Ontario International Airport Connector Project

ATTACHMENT A PUBLIC COMMENT AND RESPONSES Part B

March 2025

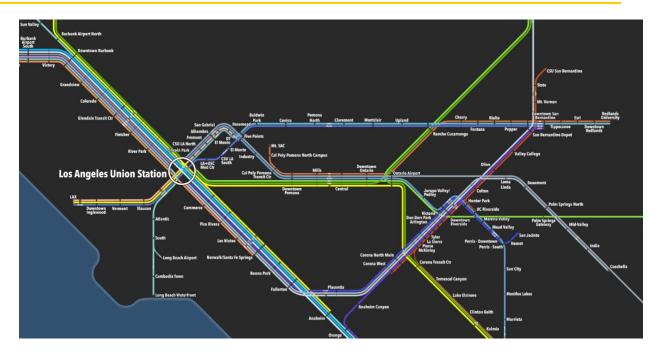
The Strategic Planning Study Report for Metro Gold Line Extension to the Ontario International Airport (2008), Advanced Regional Rail Integrated Vision – East (ARRIVE) Study (2014), Ontario Rail Access Study (2014), Hybrid Rail Service Planning Study (2018), and SCAG Los Angeles and San Bernardino Inter-County Transit and Rail Connection Study (2018) identified several viable rail alternatives, including Metrolink, Metro Gold Line (now A Line) DMU, ZEMU, and light rail extensions which have the potential to provide reliable and proven connectivity between ONT and Rancho Cucamonga Station and support frequent service across counties and a wide range of travel patterns. Such alternatives would significantly ease traffic congestion from vehicles and reduce VMT and emissions in the region, which is plagued with the worst air quality in the nation.

Refer to Master Response 1 for discussion of the Alternative development process and the discussion of the Alternatives considered but withdrawn from further consideration. As discussed in Sections 3.2, Air Quality, Greenhouse Gas Emissions, and Energy, and 3.10, Transportation and Traffic, of the EA, once operational, the Build Alternative would be a transportation improvement to first/last-mile access, which would encourage mode shift from automobiles to other modes, such as transit and non-motorized travel. As such, the Build Alternative would reduce the overall regional VMT and congestion and have a net air quality benefit, as reduced VMT results in reduced combustion emissions.

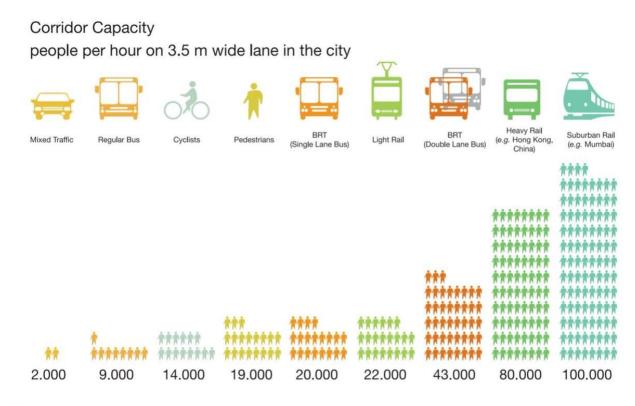
Below are the major concerns we find in the ONT Connector's Build Alternative that must be adequately addressed in the Final EIR and we feel are grounds to reject the current model:

1. Severely Limited Capacity:

The DEIR provides the following description of the service model: "The proposed Project would operate autonomous electric vehicles to transport passengers between the Cucamonga Metrolink Station and ONT. The autonomous electric vehicles would be grouped and queued at their origin station and depart toward the destination station once boarded with passengers. After the group of vehicles arrives at the destination station and passengers deboard, new passengers would board, and the group of vehicles would return to its origin station.... The proposed Project would provide a peak one-way passenger throughput of approximately 100 per hour." (ONT Connector DEIR, 2-15).

Refer to Master Response 1 for discussion of the Alternative development process and the discussion of the Alternatives considered but withdrawn from further consideration. Refer to Master Response 2 for the discussion of fleet size and capacity of the autonomous vehicle.
